Access Compliance Report

Public Rights-of-Way

| Intersection ID: 23733 | Main Street: ALLEGRO_CT | Cross Street: CEDAR_CROFT_DR | Location: | N |
| ADA ID: 4F03770BB170 | Ramp Type: PerpDiag | Initial Pass/Fail: Fail | Overall Compliance: No | Severity Score: 13.75 |

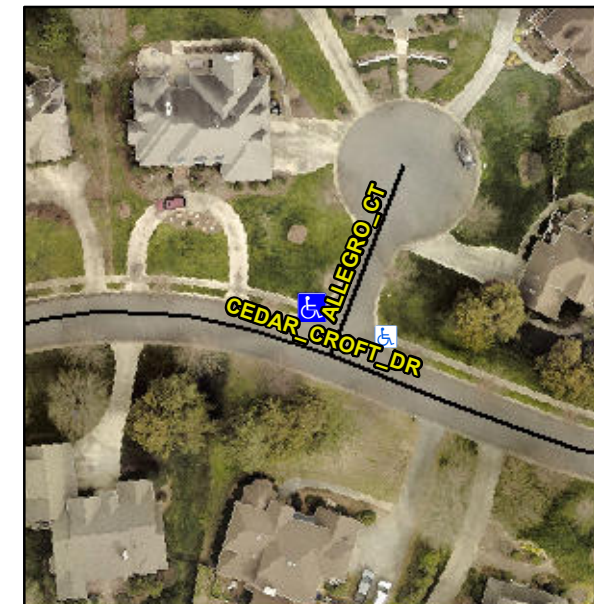
Not Found, R304.2.2, R304.5.3

| Compliance | Description | Data | Compliance | Description | Data |
|------------|-----------------------|-------|------------|-----------------------------|-------|
| N/A | Ramp Length (in) | 30.0 | No | Ramp Slope (%) | 9.3 |
| Yes | Ramp Width (in) | 48.0 | No | Ramp XSlope (%) | 2.8 |

Remove & Replace Curb Ramp With Two New Directional Ramps or Equivalent.
